Title: Proposal for an Informative Annex for SPI-3, "Protection for the Asynchronous Information Phases (COMMAND, MESSAGE, and STATUS)"

To: T10 Technical committee
From: Mark Evans and Bruce Leshay
Quantum Corporation
500 McCarthy Boulevard
Milpitas, CA USA 95035
Phone: 408-894-4019
Fax: 408-952-3620
Email: mark.evans@quantum.com
bruce.leshay@quantum.com
Date: 28 May 1999

Protection for Asynchronous Information Phases T10/99-119r5

Figure x1 – Protection code generator

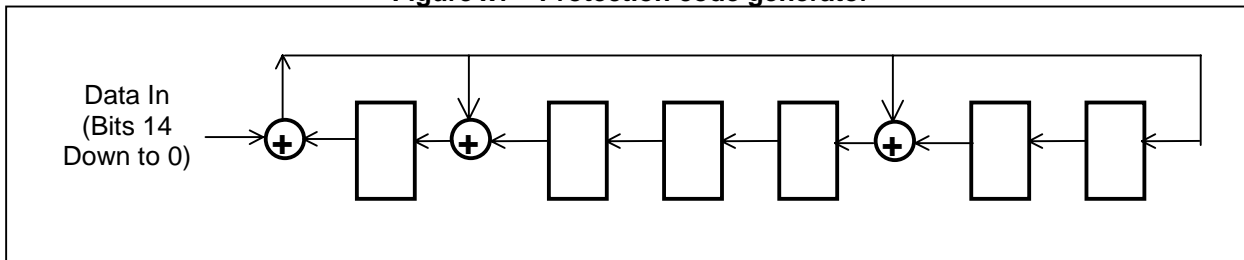
The following recommended changes from the SPI-3 working group meeting May 4th in Manchester are included in this revision: Figure x1 (Protection code generation) has been updated from previous versions of this proposal to correctly reflect the algorithm. Additional explanatory text has been added to x.1 (Code description). "Prototypes" have been added to the C code example. The C code example was moved to x5.1. The Verilog example from the reflector was added in x5.2. Examples of protection code calculations were added in x5.3. Modifications to x2 were made to allow the details of enabling and disabling the feature to be vendor specific, including examples.

The canonical form of the code generator is shown in Figure x1. This is a serial implementation: the register is initialized to zero, then the data is fed in one bit at a time, codeword bit 14 (as defined above) first, followed by codeword bits 13, 12, 11, and so on until bit 0. As each data bit is input, the shift register is clocked. When all 15 bits have been clocked into the generator, the check bits are available in the registers, check bit 0 (codeword bit 15) on the right in the diagram and check bit 5 (codeword bit 20) on the left. The + signs represent an XOR operation.
